**Re: Lot 4A Block 9 Unit 18 Volcano Cliffs, S.A.D. 228
7904 Aguila St NW
Request Permanent C.O. – Not Accepted
Engineer's Stamp dated: 6-19-17 (D10D003I4)
Certification dated: 6/11/18**

LOT 4-A, BLOCK 9, UNIT 18
VOLCANO CLIFFS SUBDIVISION

BURK - GRADING & DRAINAGE PLAN

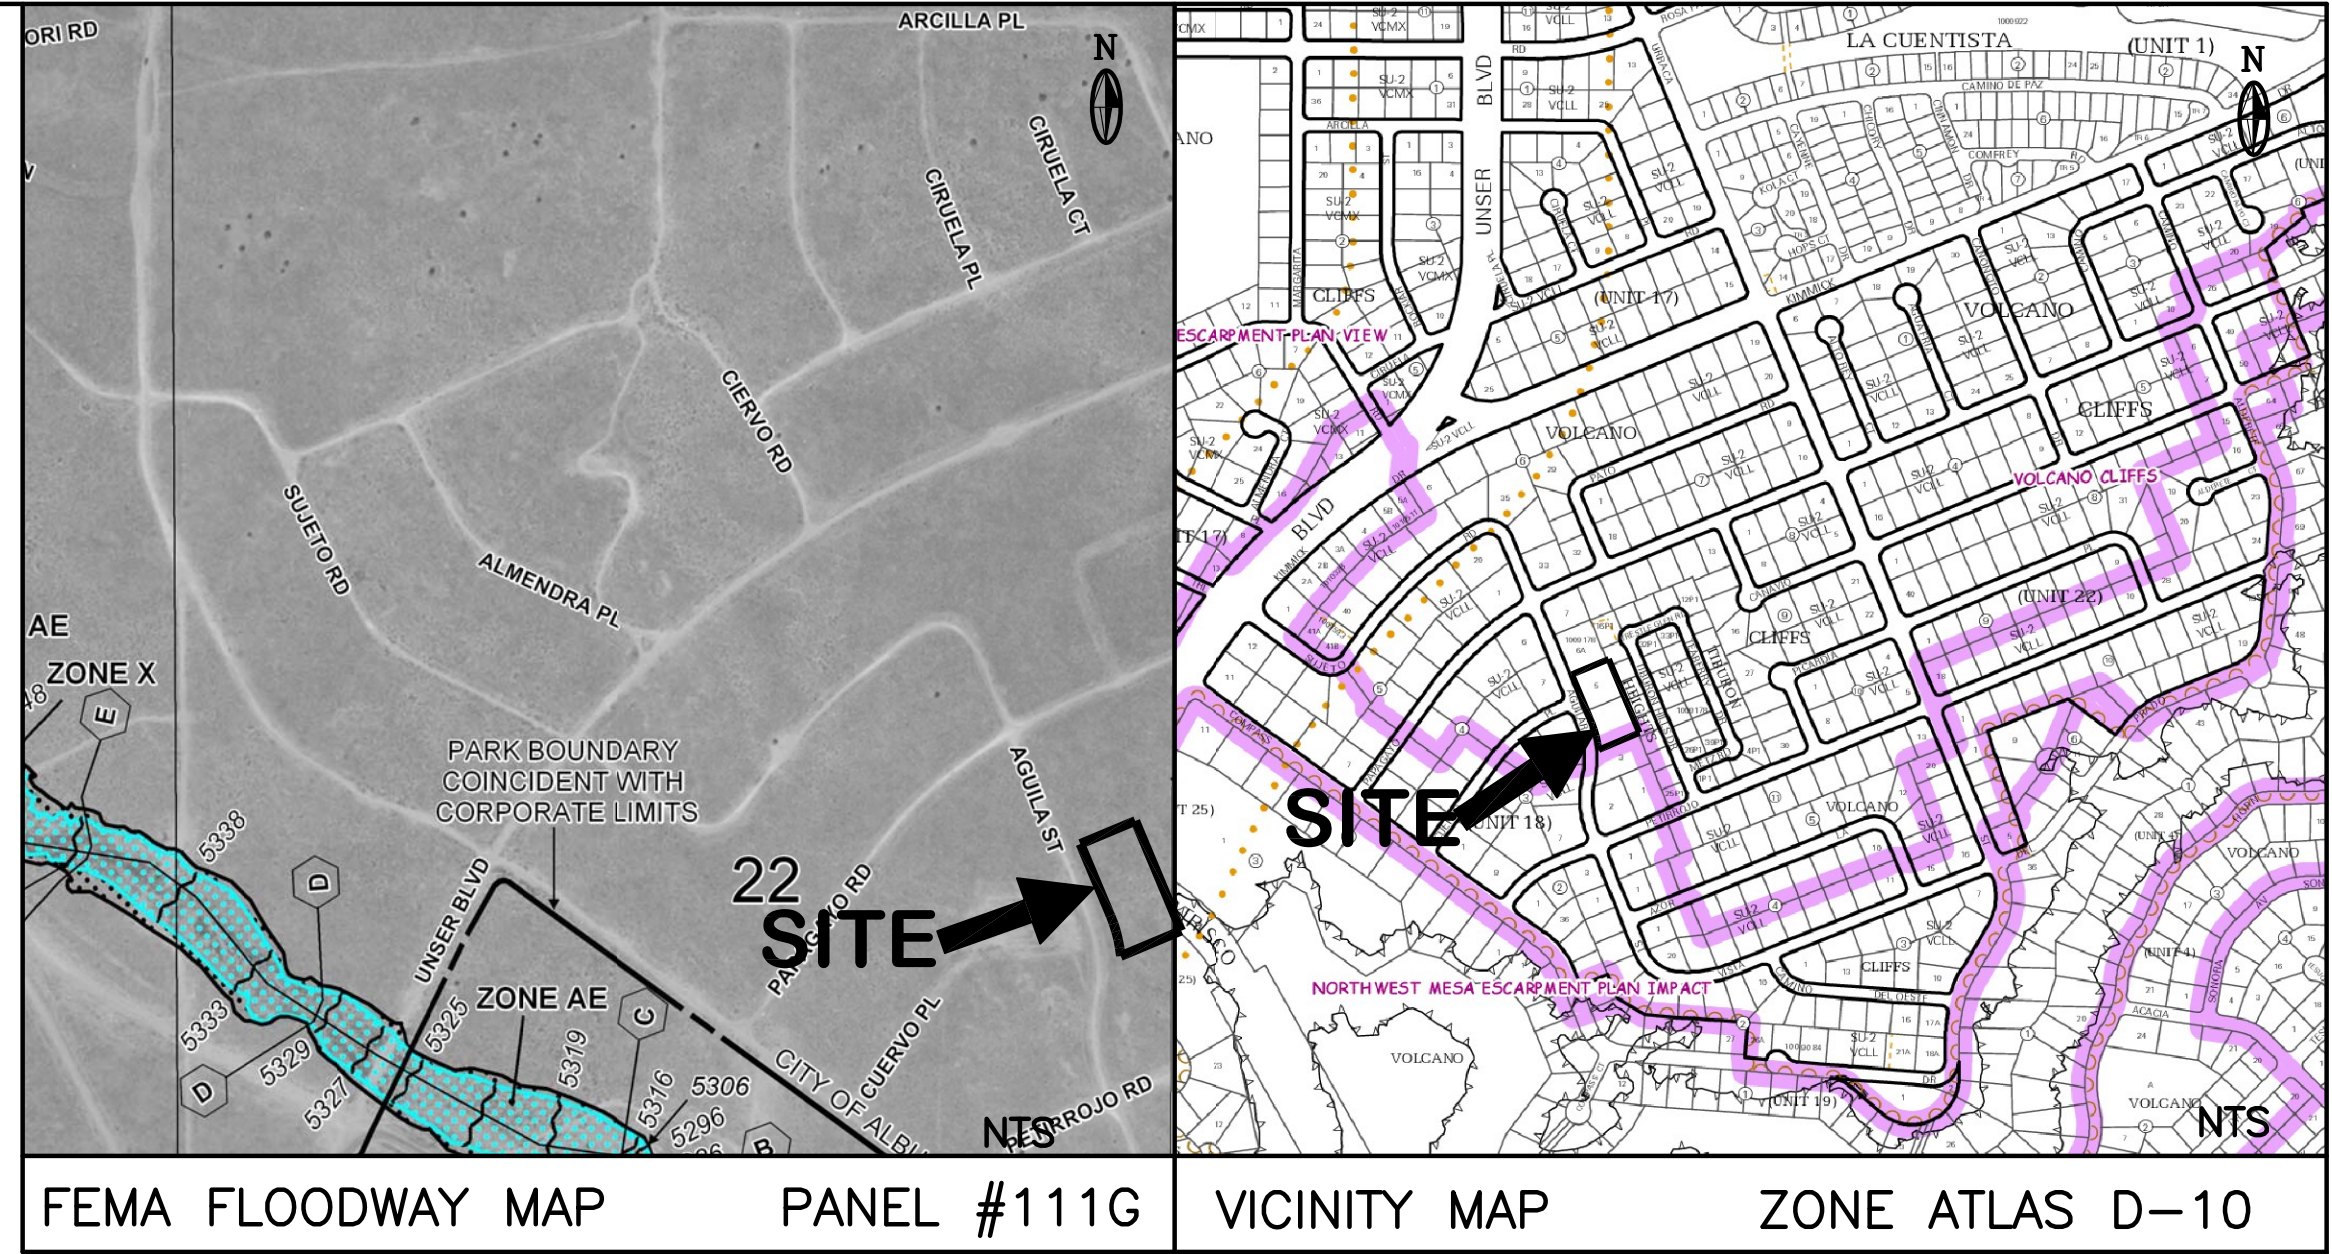
Based on the Certification received 6/11/18, the site cannot be accepted for release of Certificate of Occupancy by Hydrology until the following comments are addressed.

- Remove dirt piles in street.
- Replace buckled sidewalk.
- Remove debris from site.
